**As-Built Baseline Monitoring Report**

**COWFORD PROJECT**

NCDMS Project #100095 (Contract #0007746)

**RE: DMS Comments on the Draft Mitigation Plan  
Cowford, Project ID #100095, DMS Contract #0007746**

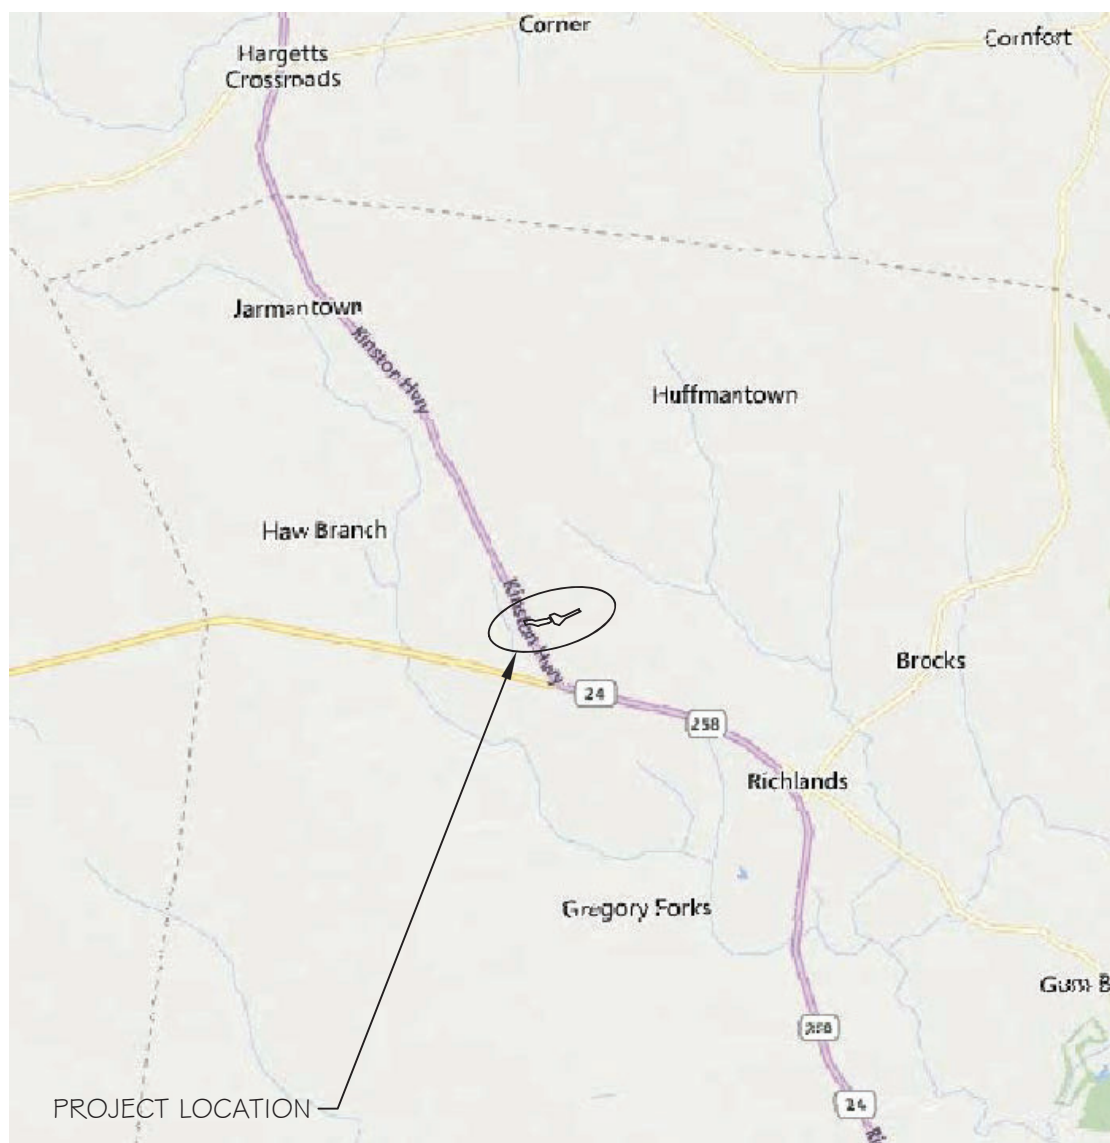
6. Add construction and as-built drawings to back of report.  
[Done.](#)
7. Confirm with surveyor that points 20-22 on the plat were installed and are marked.  
[Points 20-22 have been confirmed and are marked.](#)
